Office Action Summary

10/602,286

Claims 1-22 are rejected under 35 U.S.C. 102(b) as being anticipated by Taunay (U. S. Patent no. 4,679,841).

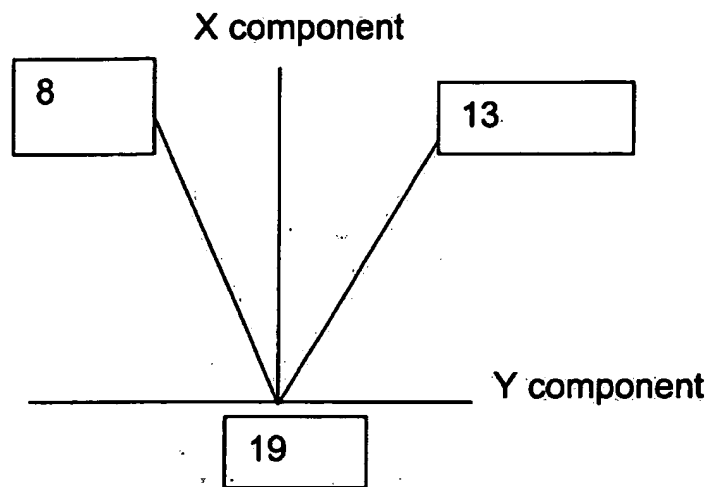
Taunay discloses:

Vehicle closure member 1, Arm 9 with first segment between pivot point 8 and pivot point 19 and second segment between pivot point 13 and pivot point 19, extension member 12, gas spring 5 with two segments, hinge assembly 3, roller 17

Taunay discloses biasing the roller against the vehicle closure member in column 2 lines 55-58.

The second segment is directly in contact with the closure member through intermediate parts in the exact same way as the instant invention (roller is between the closure member and the second segment of the arm).

Regarding claims 18 and 19, examiner refers to the following figure

The two segments extend in opposite and parallel directions along the y axis in the exact same way that the instant invention does. The instant invention is not a straight bar but is a "W" shape. The legs of the segments extend in both the x and y directions in the same way as the link of Taunay.
